VALUE ENGINEERING STUDY

Project # STP00-2009-00(004) PI No. 742870-
SR 920 from SR 54/Fayette to SR 3/US 19/Clayton
Fayette/Clayton County, Georgia

16 May 2013

PROPOSAL NUMBER: R-12.0

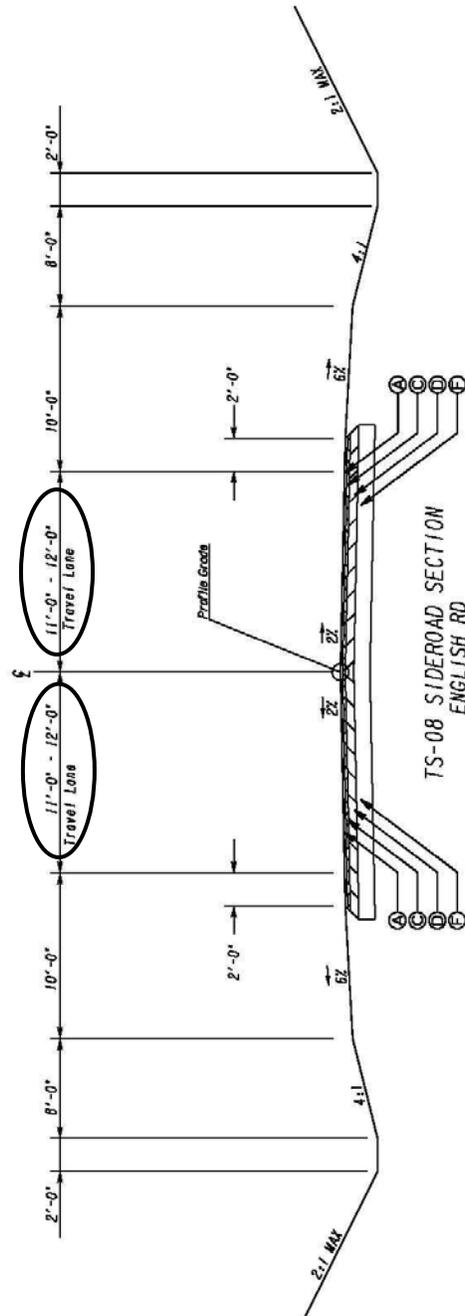
PROPOSED CHANGE: It is proposed to construct all new travel and turn lanes on the side roads with a width of 11'. The side roads to be included in this width reduction include Zoie Court, Folsom Road, Southwood Drive, Pebble Ridge Drive, and Shannon Circle.

Proposed Change: Revise 12'0" lanes to 11'0" max.

PROPOSAL NUMBER: R-13.0

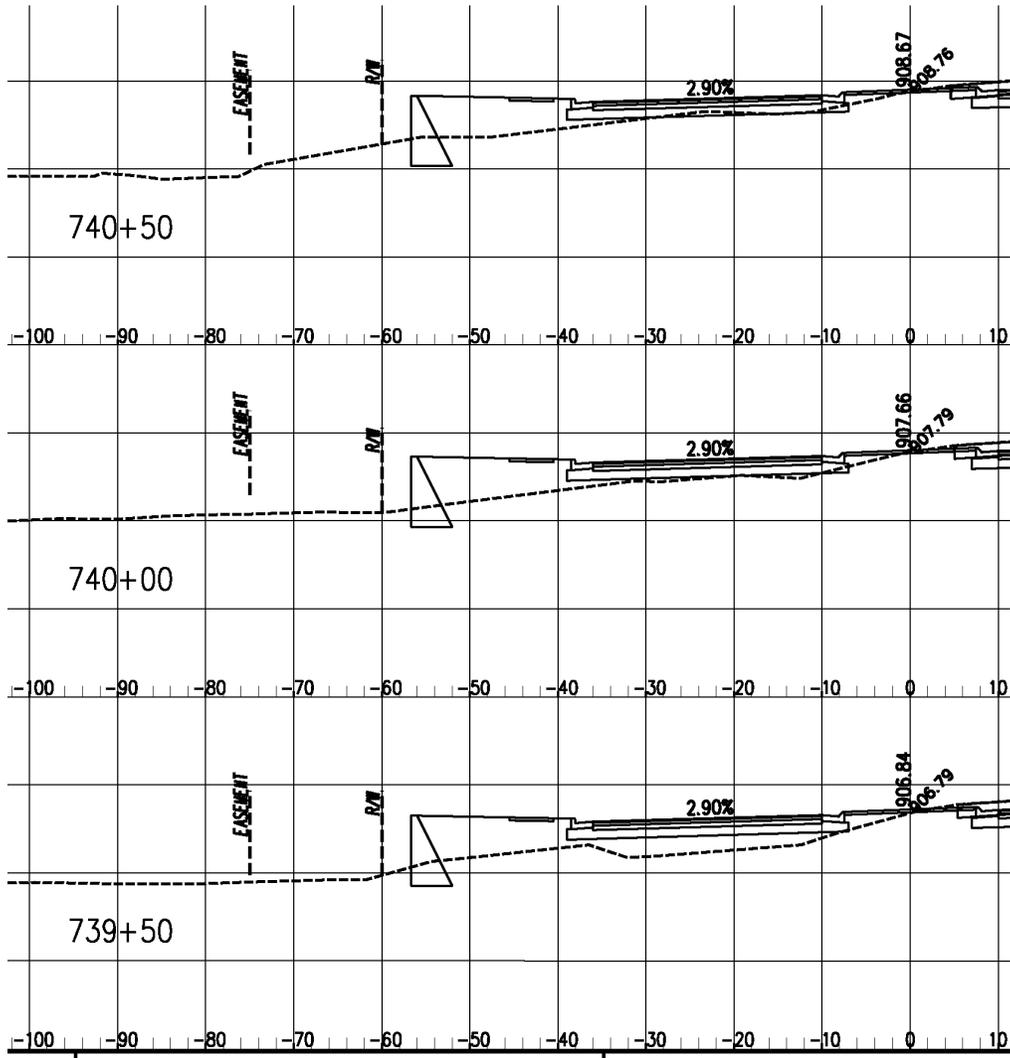
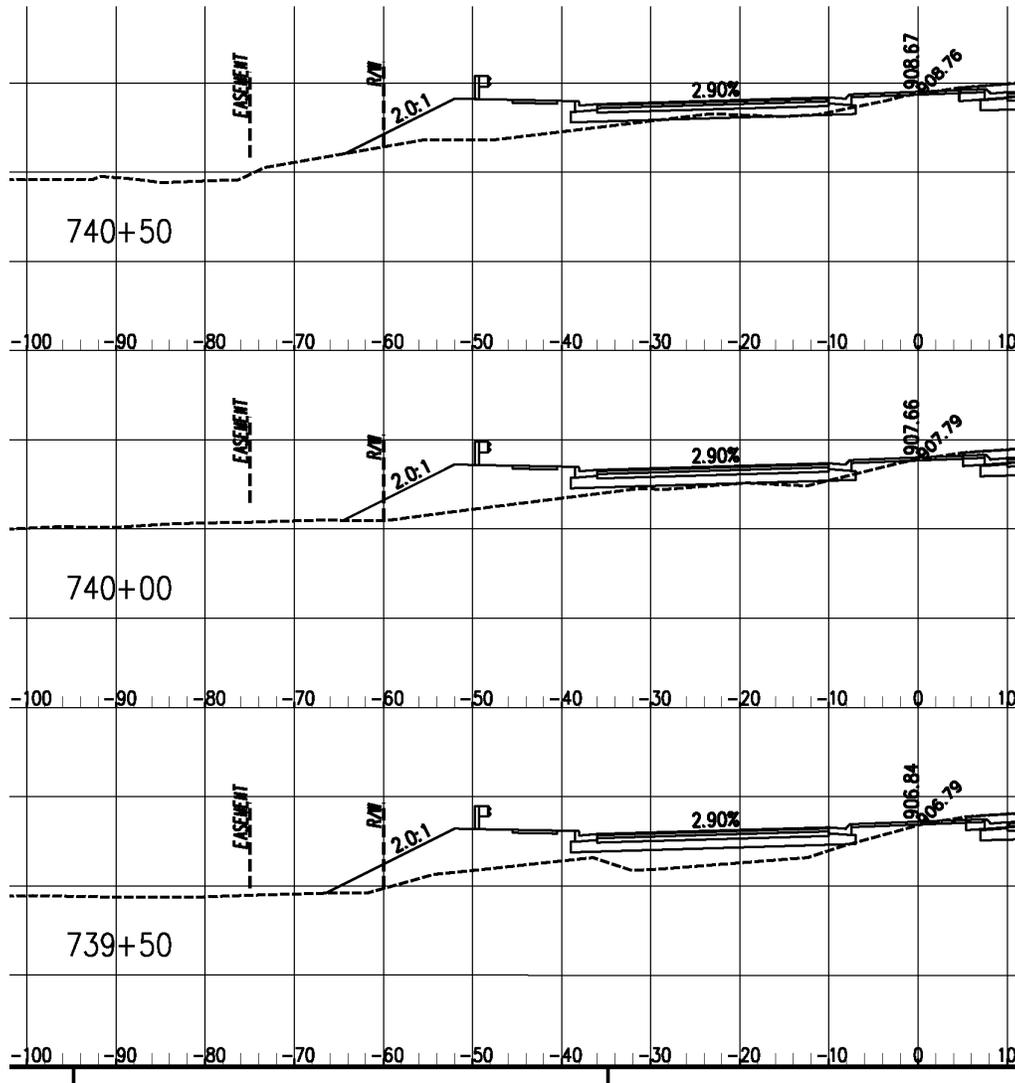
PROPOSED CHANGE: It is proposed to use 2:1 fill slopes and guardrail at 6 of these locations and eliminate the walls. Note: costs for this proposal calculated using gravity wall as shown in original design; it is anticipated that these walls will need to be changed to Parapet walls which would result in greater cost savings.

PROPOSAL NUMBER: R-14.0

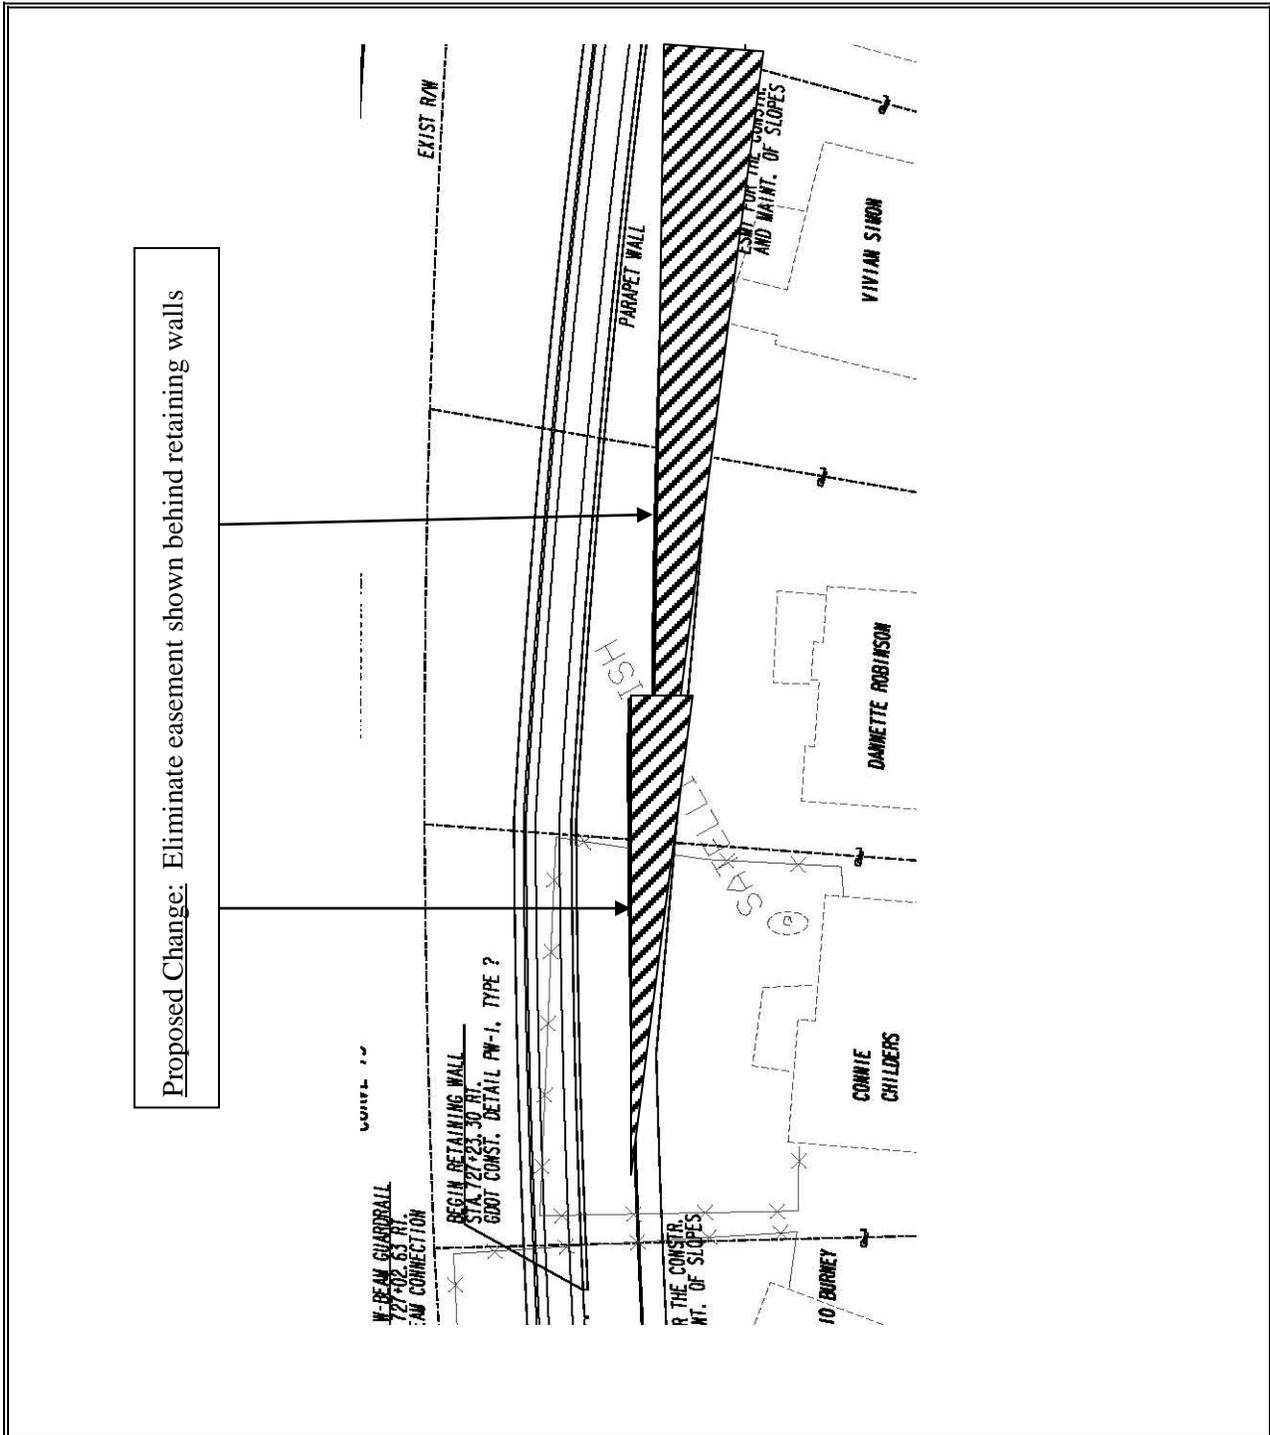
PROPOSED CHANGE: It is proposed to eliminate the easements beyond the right-of-way limits at the location of proposed new retaining walls. In addition, it is proposed to eliminate the extraneous easement areas shown in the vicinity of the Hurricane Creek bridge. See attached calculation sheet for a list of the project locations where this is proposed.

PROPOSAL NUMBER: R-17.0

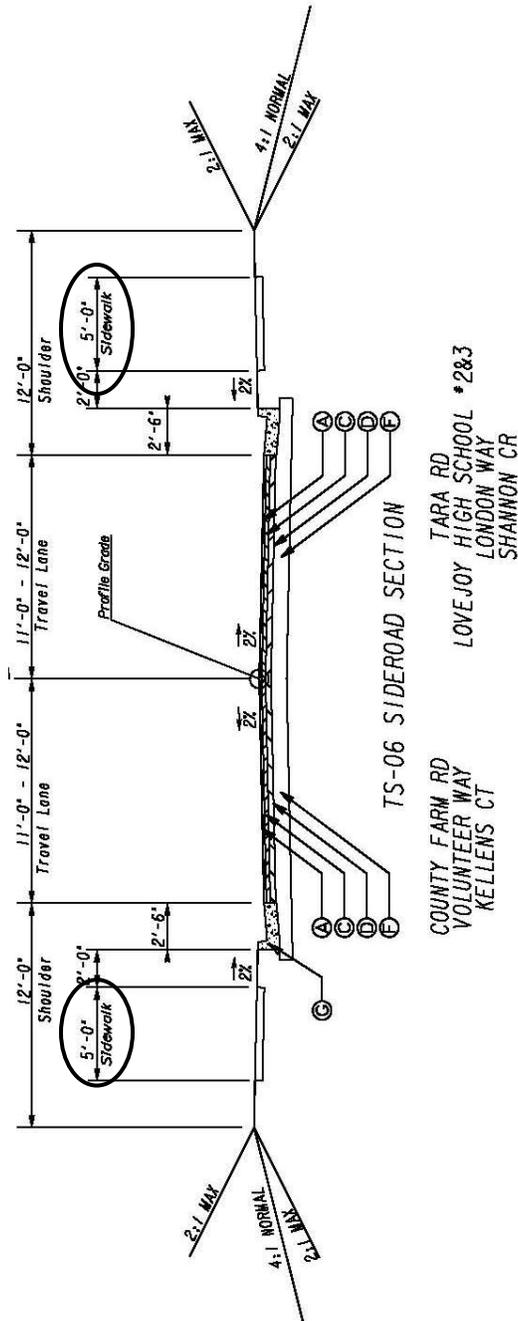
PROPOSED CHANGE: It is proposed to eliminate the sidewalks from the new roadway sections for side roads where no sidewalks currently exist. See attached calculation sheet for a list of the roads.

Proposed Change: Eliminate sidewalks where none exist

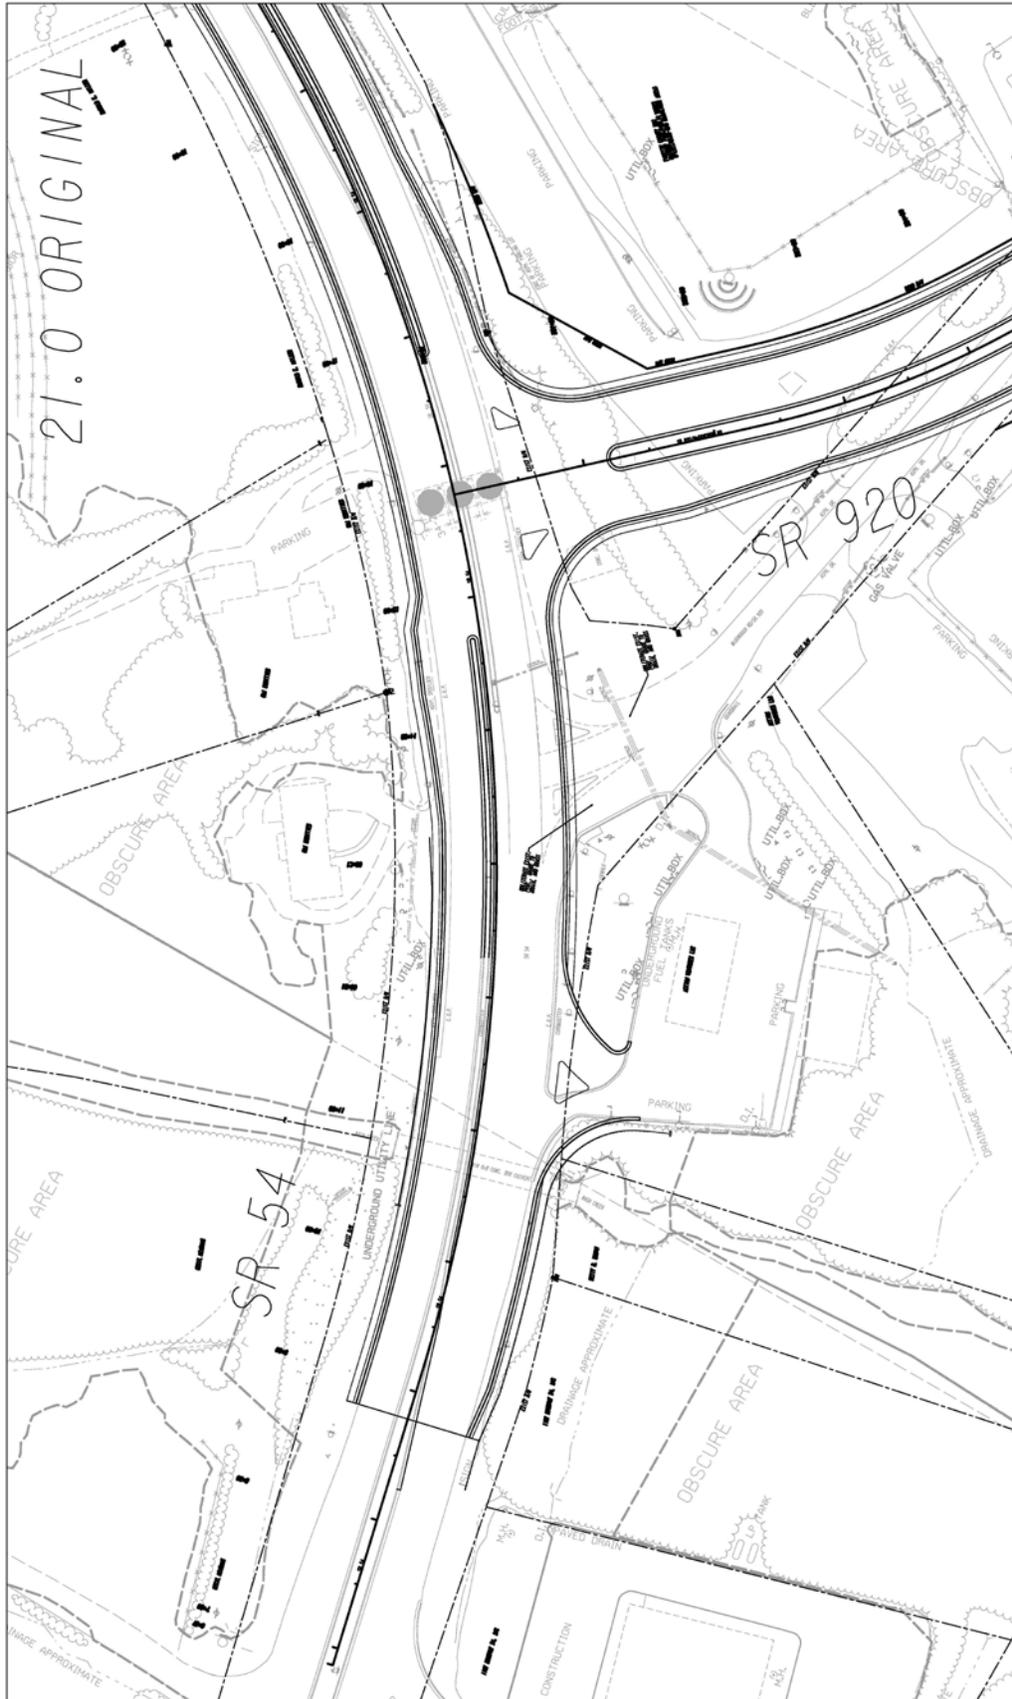
PROPOSED CHANGE: It is proposed to eliminate the overlay, curb and gutter and sidewalk on SR 54 South of the realigned intersection of SR 920 and SR 54.

PROPOSAL NUMBER: R-29.0

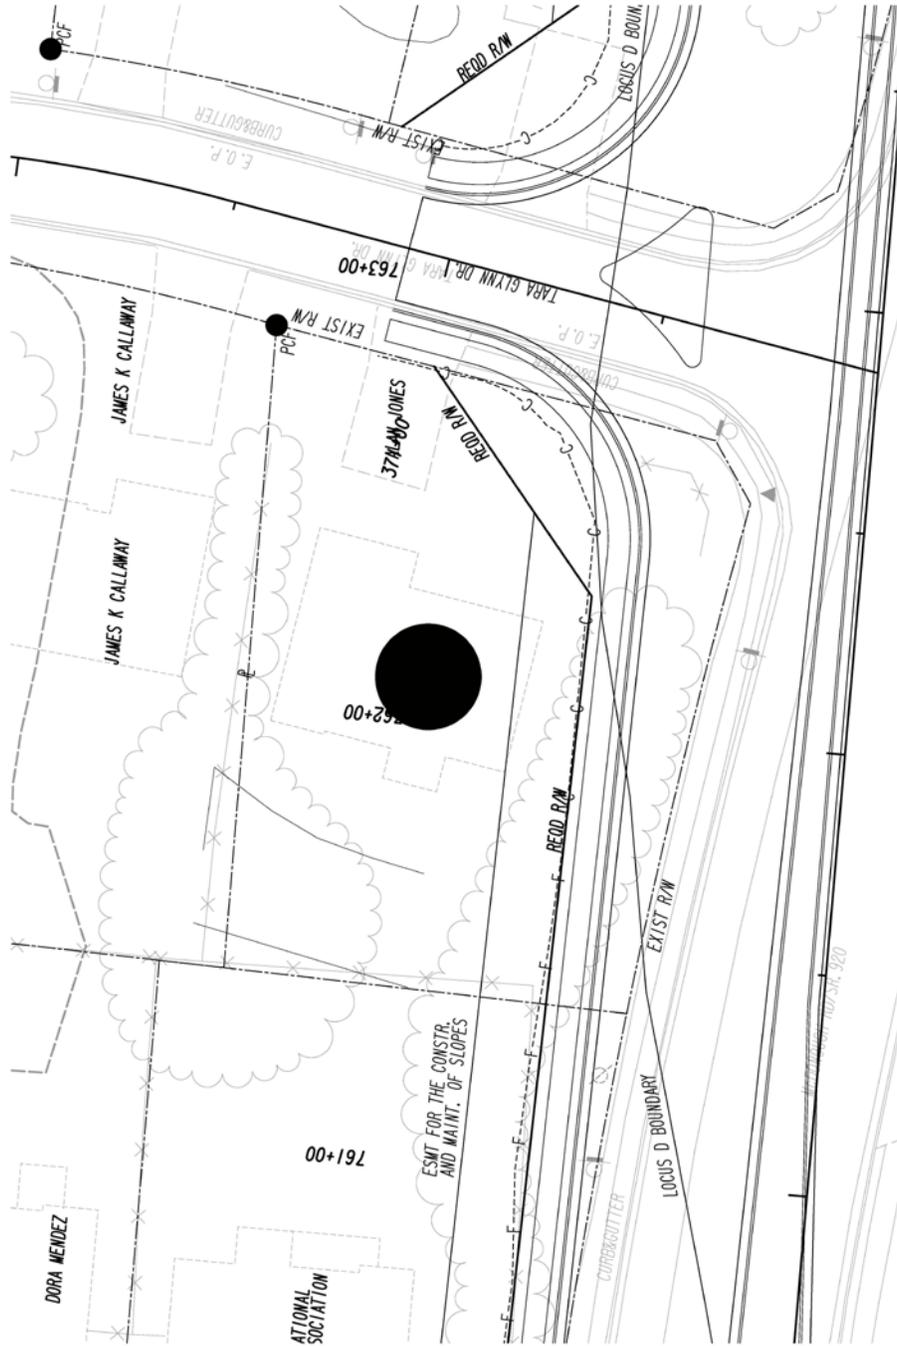
PROPOSED CHANGE: It is proposed to reduce the permanent easement to 10' to eliminate the displacement of the residential structure.

Proposed Change: Reduce permanent easement to 10' and avoid Displacement
